FEDERAL ENERGY REGULATORY COMMISSION
Washington, DC 20426
March 14, 2023

Project No. 1494-438–Oklahoma
Pensacola Hydroelectric Project
Grand River Dam Authority

**Reference: Determination on Requests for Study Modifications and New Studies
for the Pensacola Hydroelectric Project**

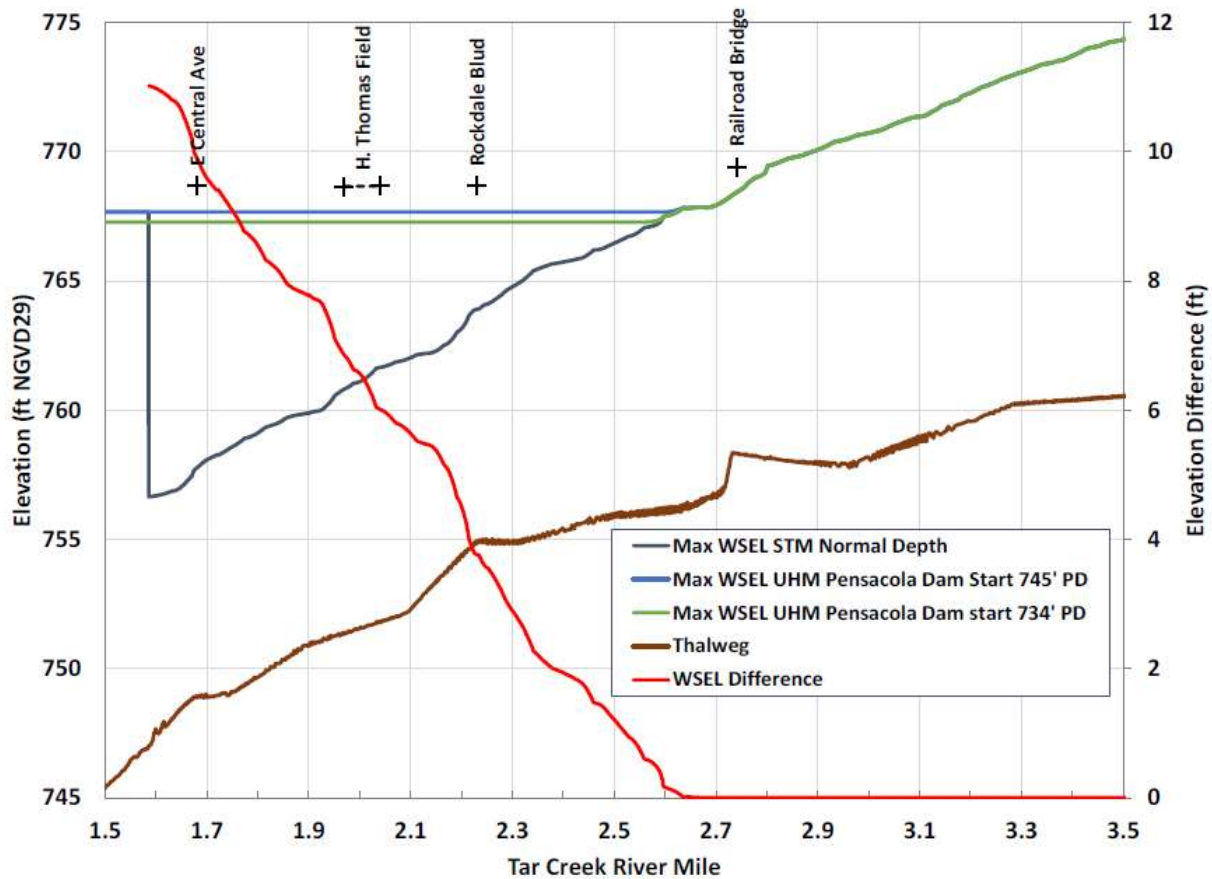
Based on staff's review of the City's November 29, 2022 comments on the USR, and staff's additional consideration of Tar Creek boundary conditions, there may be issues with the 1-D UHM in need of resolution.²³ GRDA developed the 1-D UHM to be compatible with the sedimentation and erosion functions in HEC-RAS as needed to produce the Sediment Transport Model (STM). The City's issue with the 1-D UHM is most visually apparent in the City's figure K (inserted as figure 1 below)²⁴ which shows a

model run resulting in a sudden, physically improbable, steep rise in the simulated water surface elevation of 10.5 feet at mile 1.6 of Tar Creek.

In addition, we have identified other questions related to the 1-D UHM. According to Chapter 7 of the HEC-RAS User's Manual, there are several types of boundary conditions that can be applied at the downstream end of a reach. Using either a downstream rating curve or normal depth boundary condition is most applicable in this case. The HEC-RAS manual explains that when applying the downstream rating curve boundary condition, the model is susceptible to error when the slope of the water surface is low, as is the case at lower Tar Creek. GRDA chose the normal depth as the boundary condition for lower Tar Creek.

The HEC-RAS manual states that when using the normal depth as the boundary condition, a friction slope (slope of the energy grade line) must be entered. The slope of the water surface is often a good estimate of the friction slope but is difficult to obtain ahead of time. Consequently, the average bed slope in the vicinity of the boundary condition location is often used as an estimate for the friction slope.²⁵ According to GRDA, the downstream boundary condition used for Tar Creek at the Neosho River confluence is based on normal depth with a friction slope assumed equal to the streambed slope, at 0.0033 foot per foot (ft/ft). According to the Digital Elevation Model (DEM) provided by GRDA, the ground slope along the downstream 1.6 miles of Tar Creek is approximately 0.0025 ft/ft, which is reasonably close to the 0.0033 ft/ft slope used by GRDA.

Based on the HEC-RAS 2-D UHM, however, the slope of the water surface (approximately equal to the friction slope) appears to be lower by one to three orders of magnitude than the ground slope estimates. For the September 1993 simulation (water surface elevation 745 feet PD at the dam), the slope of the Tar Creek water surface from

If the backwater from the Neosho River increases water surface elevation and inundation areas compared to a similar Tar Creek discharge without backwater, as indicated in the City's figures below, velocities between river miles 1.6 and 2.4 of Tar Creek could be significantly less than those predicted by the 1-D UHM. Moreover, the improbable 10.5-foot increase in surface elevation displayed by the City and related issues with the model could affect predictions for transport (or deposition) of sediment at the downstream end of Tar Creek between river miles 1.6 and 2.4.

To ensure that the water velocity, inundation area, and surface elevations estimated by GRDA's 1-D UHM are reasonably accurate, we recommend that GRDA revise the downstream boundary condition for Tar Creek at the Neosho River confluence to reflect a flatter friction slope (if normal depth is used) or use a different downstream boundary condition, as appropriate. In the process, we recommend that GRDA correct the apparent and anomalous 10.5 foot difference in water surface elevations beginning at river mile 1.6 as indicated in the City's figure L (figure 1 below). We also recommend that GRDA then re-run the Sediment Transport Model and revise the portions of the sedimentation study where the results differ significantly from those reported in September 2022. GRDA should file an updated Sedimentation Study Report with the results of the above recommended revisions and re-runs within 30 days from the issuance date of this determination. Finally, GRDA should file updated model inputs and outputs for the 1-D UHM, STM, and any other updated model.

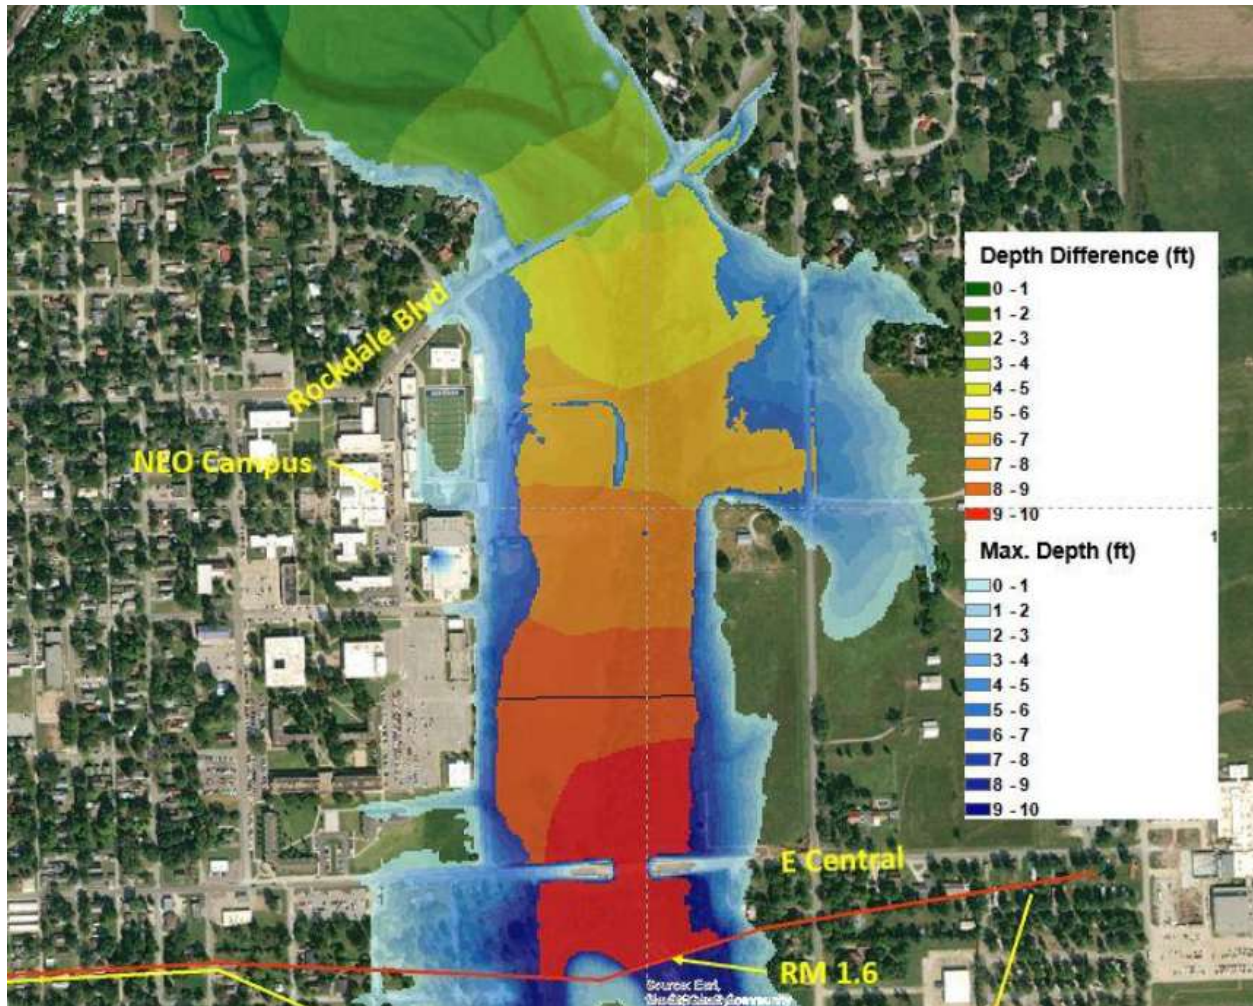
Neosho River, based on starting water surface elevations at Pensacola Dam of 734 feet and 745 feet PD, respectively. The red line represents the difference in water surface elevations (on the right axis) along Tar Creek between the "with backwater" and "normal depth" model runs.
